GRPE Working Group on VIAQ –  
Evaluation of test procedure  
“Draft Part IV of the Mutual Resolution (M.R.3) on Vehicle  
Interior Air Quality,,

Measurements and recommendations by OICA.  
October, 11th, 2024

# RESULT OF ASSIGNED TRAFFIC PERCENTAGES.

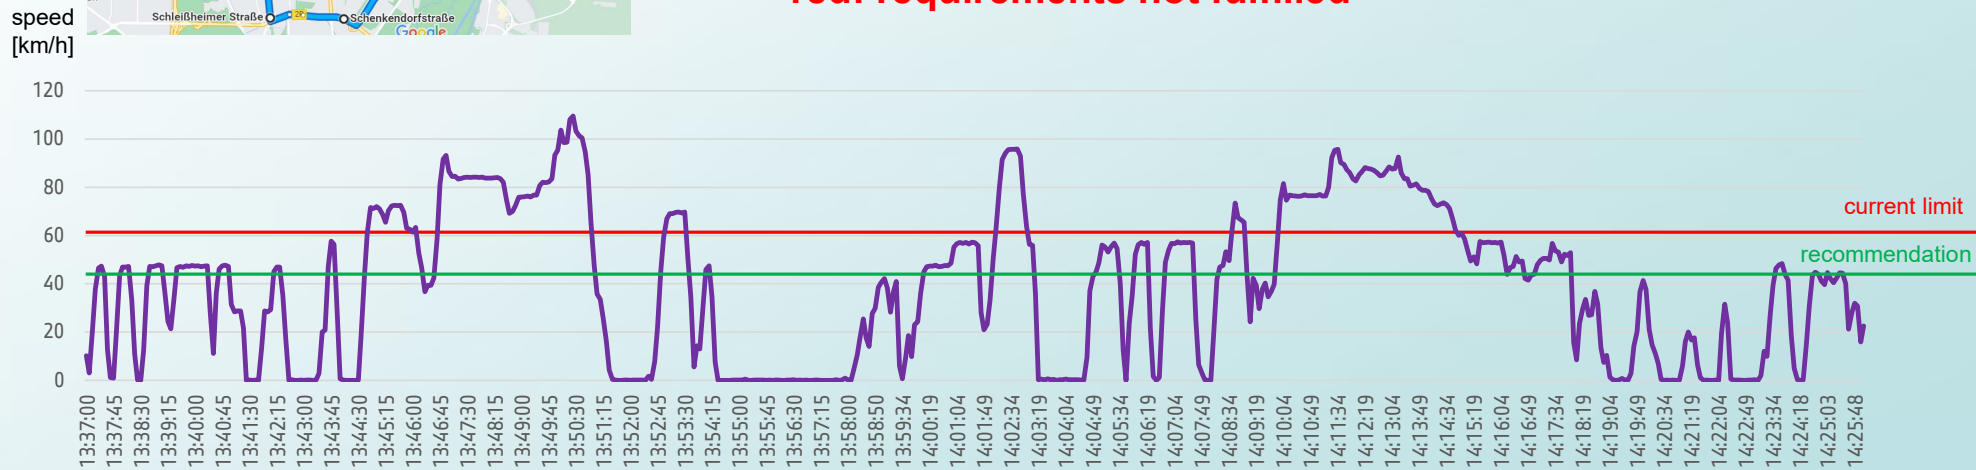
Weather: calm, **dry**, temperature: **+ 15° C**, humidity: **62 %**  
atmospheric pressure: **96.0 kPa**, Test track length: 30 km  
**55% +/-10% urban traffic percentage < 60 km/h: → 74.3 %**  
**45% +/-10% outside city traffic percentage > 60km/h < 100km/h: → 25.7 %**  
measurement time (30 – 60 min): **49 min**

→ traffic percentage limit exceeded. recommendation: change limits or required percentage

### **Assigned time intervals for specific speeds have not been reached**

- High speed of 60-100 km/h for 45% +/- 10% of test cycle is difficult to achieve
- reduce high speed contribution to e.g. 30% +/- 10%
- Definition of urban speed may also be changed to  $v < 50$  km/h e.g. 45 km/h (50 km/h city speed limit)

# RESULTS: PM 2.5 INSIDE AND OUTSIDE @ MAXIMUM/MINIMUM POLLUTION.

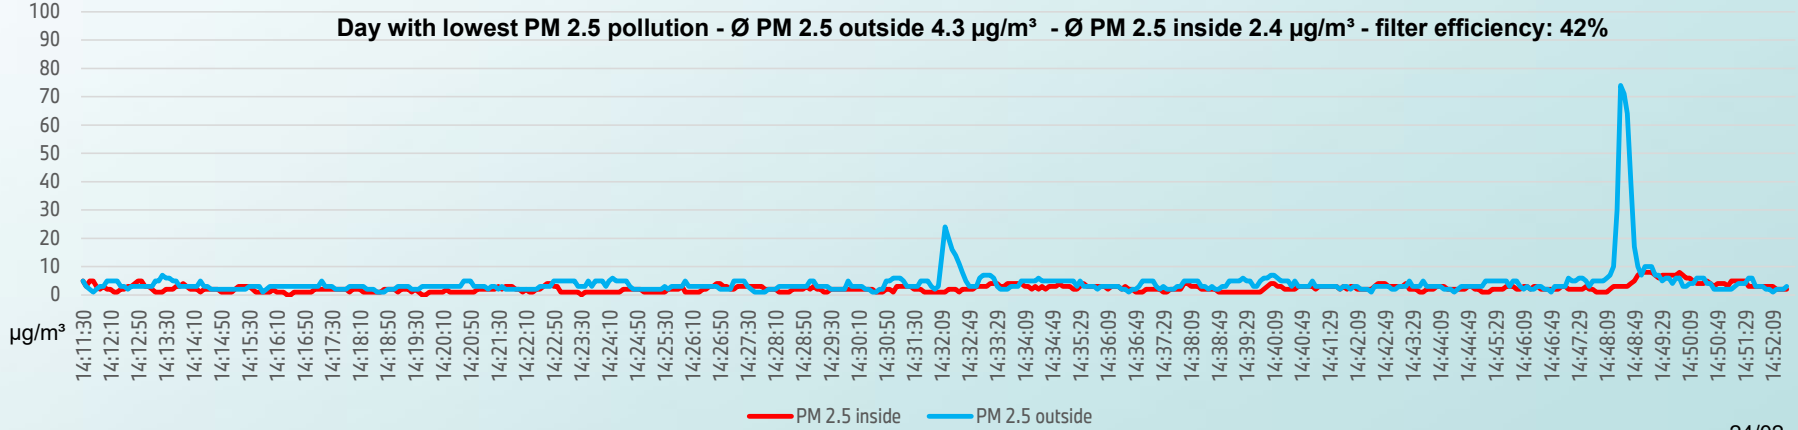
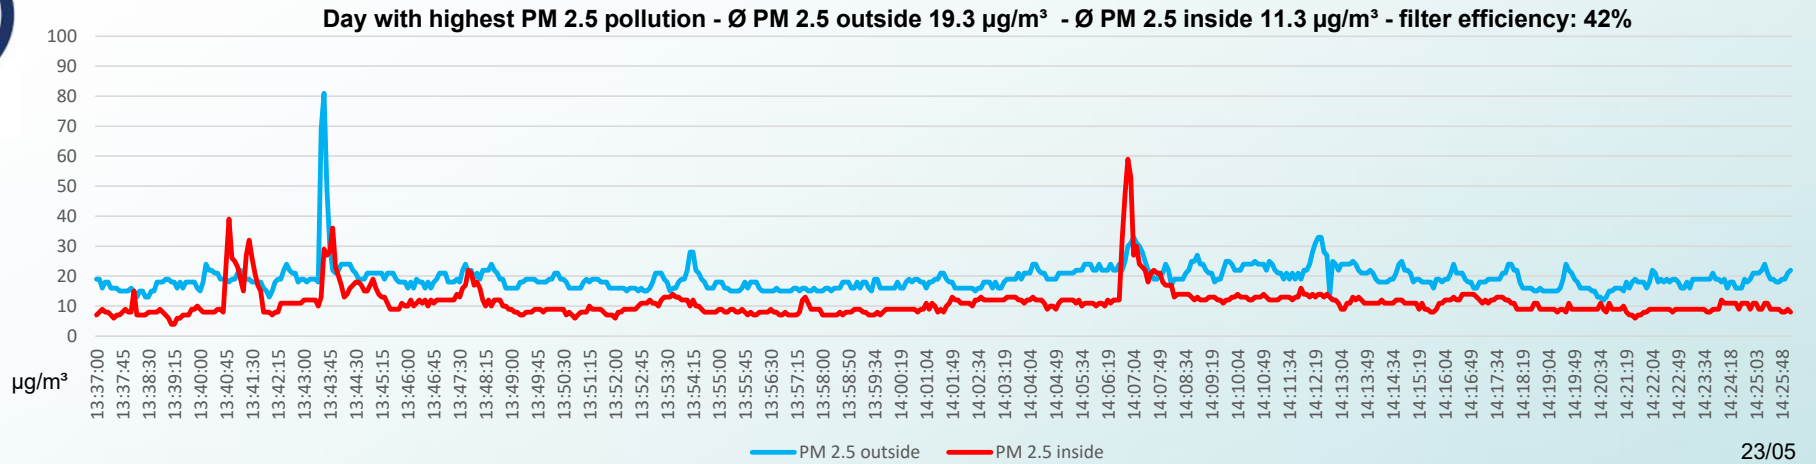
→ outside PM 2.5 concentration usually < 20 µg/m<sup>3</sup>  
→ Sensor PM 2.5 range: 0...500 µg/m<sup>3</sup>, maximum sensor tolerance: +- 10 µg/m<sup>3</sup>

# PM 2.5 LONG-TERM MEASUREMENT @ MAIN ROAD MUNICH 2013 - 2023.

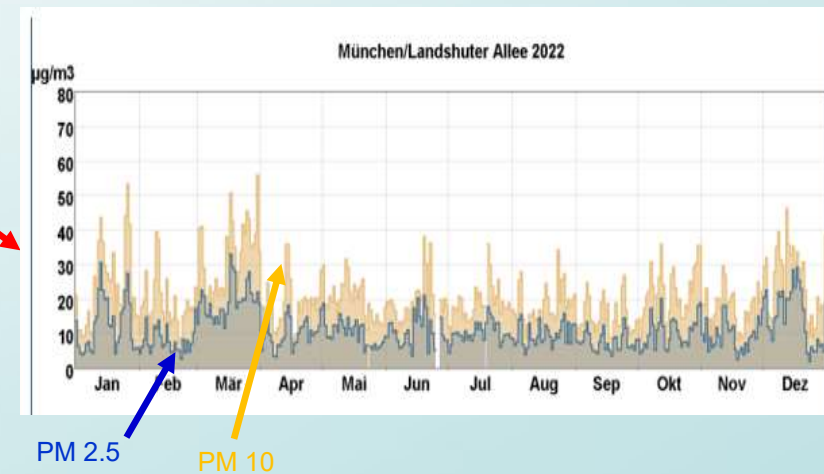
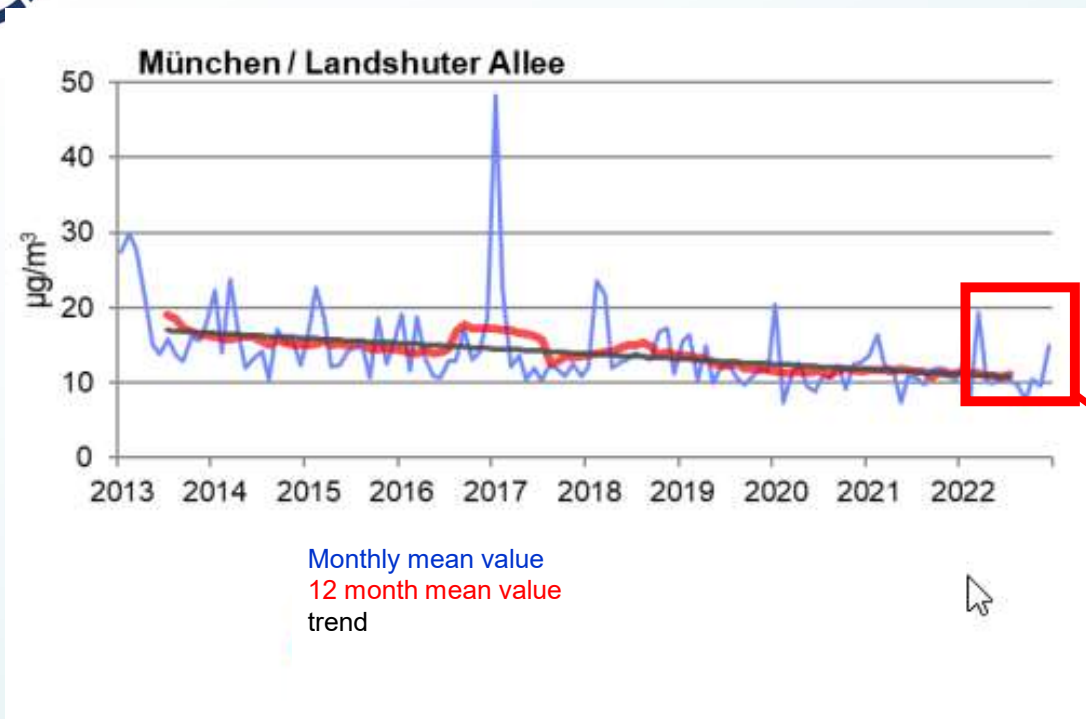
→ Long term PM 2.5 measurement in Munich shows decrease, mean value approximately 10 µg/m<sup>3</sup>

### **Long term PM 2.5 measurement in Munich show decrease, mean value approximately 10 $\mu\text{g}/\text{m}^3$**

- reduction of assigned PM 2.5 minimum (30  $\mu\text{g}/\text{m}^3$ ) recommended, e.g. 10  $\mu\text{g}/\text{m}^3$  (new WHO guideline)
- check measurement equipment tolerances

# CO<sub>2</sub> MEASUREMENT @ REAL DRIVING CONDITIONS.

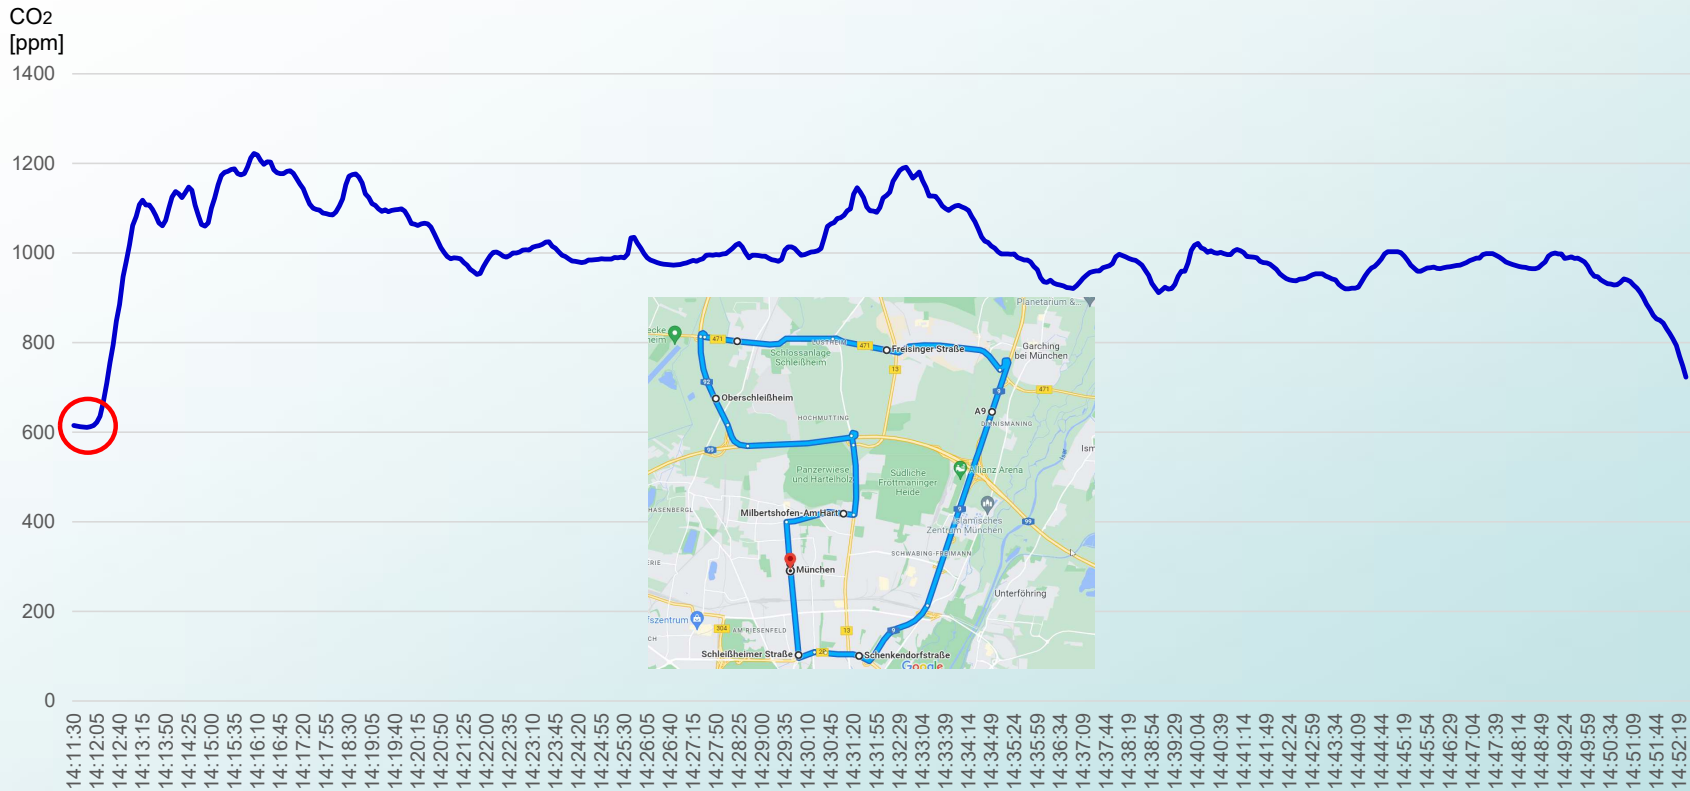
- Mean value of 4 identical sensors inside the vehicle.
- 2 persons inside vehicle, A/C on, automatic air recirculation on.
- Unexpected ambient measurement value -> comparison of 3 different CO<sub>2</sub> sensors conducted.

# COMPARISON OF 3 CO<sub>2</sub> SENSORS @ PARKING, A/C OFF, FAN OFF.

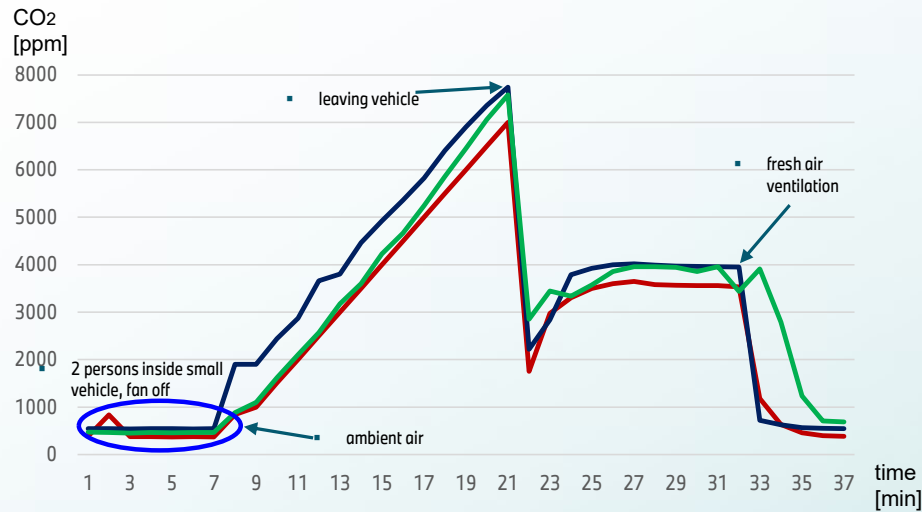
- Sensors do not show equal results (ambient and tops), also a different response time is noticeable.
- Ambient air differs between: 372 ppm, 455 ppm and 498 ppm (target: 413±20 ppm)
- Ambient air measurement results are within the respectively sensors tolerance.
- What experience do you have? What is your measured city CO<sub>2</sub> ambient value?

### **Different CO<sub>2</sub> sensors do not show equal results and also have different response times**

- Ambient air results were: 372 ppm, 455 ppm and 498 ppm (target: 413 +/- 20 ppm)
- Increase of ambient air tolerance is recommended (e.g. 420 +/- 100 ppm)
- Sensors 10% tolerance and/or +/- 100 ppm tolerance should be accepted
